STAFF REPORT

REGIONAL CENTER HEARING EXAMINER - HIGH IMPACT CASE

Case Number	2025-REG-033
Address (approx.)	2955 North Meridian Street
Location	Center Township, Council District #12
Petitioner	2955 Indy IN, LLC, by Michael Rabinowitch
Zoning	C-S (TOD) (RC)
Request	Regional Center Approval for provide for a mixed-use development consisting of a dance studio, commercial retail, and residential uses, including townhomes and multi-family dwellings.

North elevation – dance studio – revised

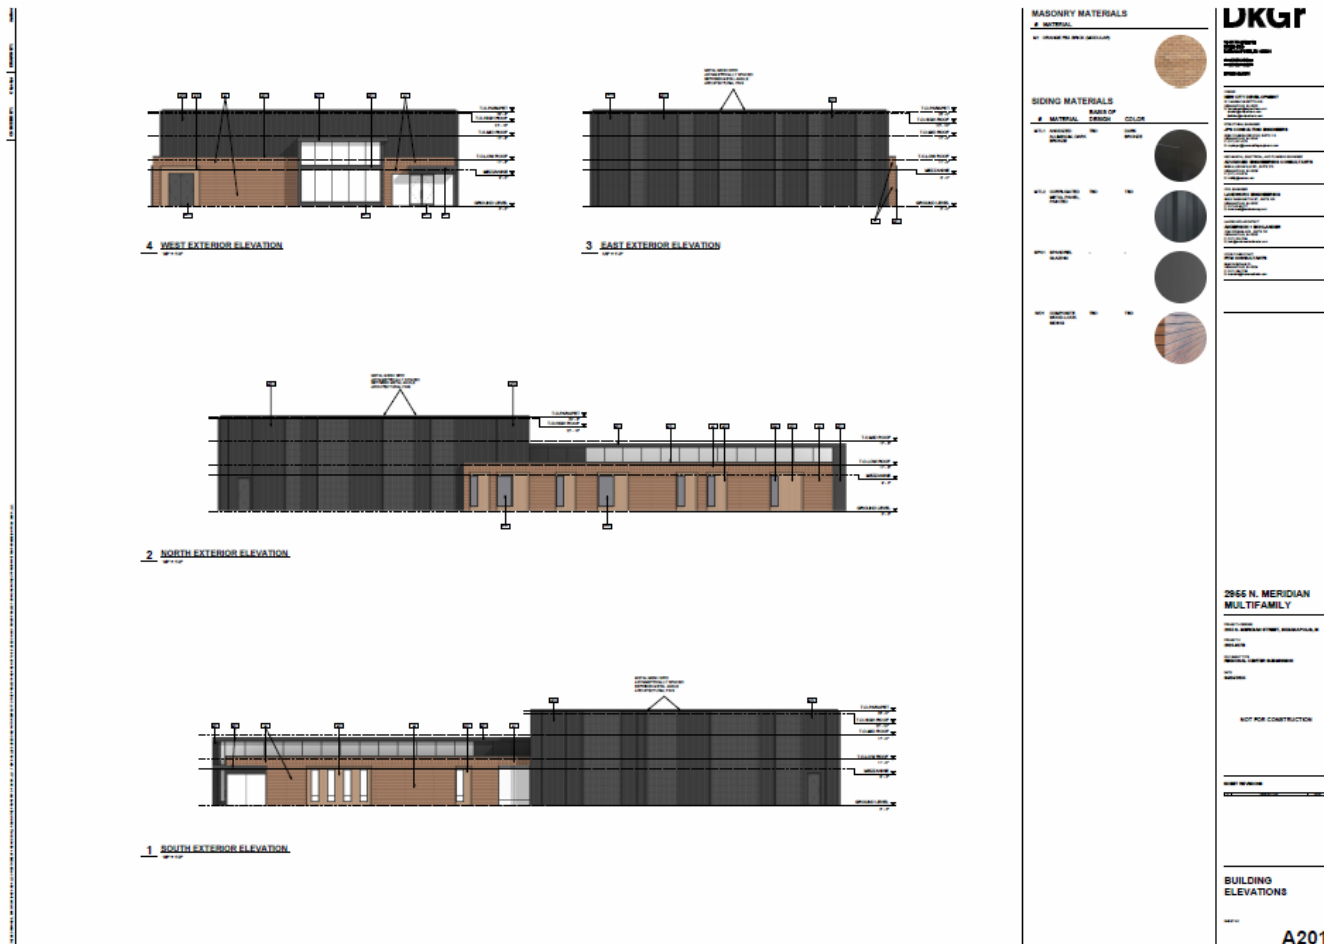
3. The proposed dance studio would have reduced transparency along Talbott Street and 30th Street. Additionally, pedestrian access to the structure would be from the surface parking lot to the west and south of the building. The dance studio will be for kids, so privacy is paramount for their safety. Therefore, Guidelines SC 1.3.2, SC 2.2.1, SC 2.2.2, SC 2.6.1, and CA 3.1.4 are waived.
